**Nuclear Regulatory Commission's
Request for Additional Information
on the Draft
Waste Incidental to Reprocessing Evaluation
for Waste Management Area C
at the Hanford Site**

Chris McKenney, David Esh, and Hans Arlt

Division of Decommissioning, Uranium Recovery, and Waste Management (DUWP)
Office of Nuclear Material Safety and Safeguards (NMSS)
U.S. Nuclear Regulatory Commission (NRC)

Thursday, May 30, 6:00 – 8:00 p.m.
Richland, WA

Figure C-1 from the WMA-C PA

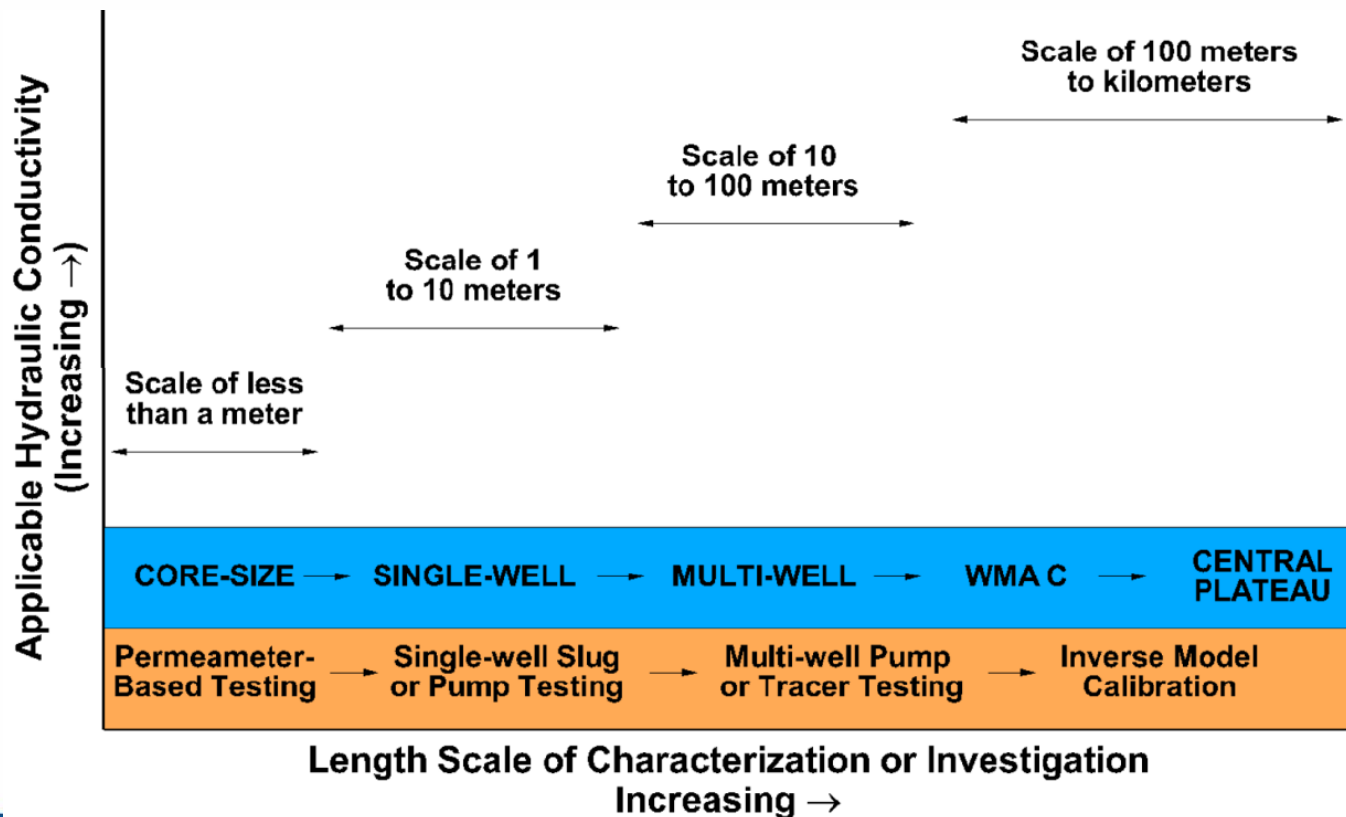
RAI 2-10 Comment: Additional information is needed to support a technical basis for using a relatively high hydraulic conductivity value for the unconfined aquifer.

- The WMA C PA document shows that the saturated zone Darcy flux is an important parameter.

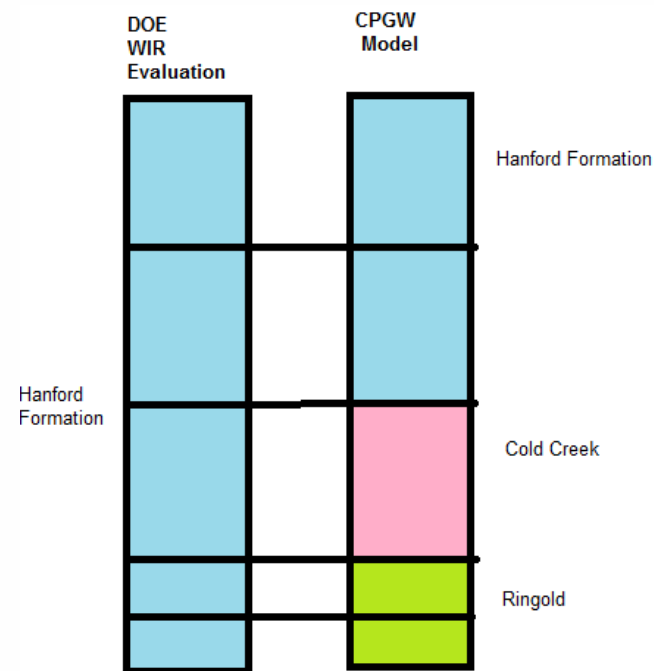
RAI 2-13 Comment: Differences in the conceptual hydrogeological models near WMA C between the regional Central Plateau Groundwater (CPGW) model and the WMA C STOMP model are considerable and some of the techniques for abstracting information and data from the CPGW model to the STOMP model require additional information.

- Differences in the hydrogeological units between the STOMP model in the WIR Evaluation and the CPGW model (see example figure).
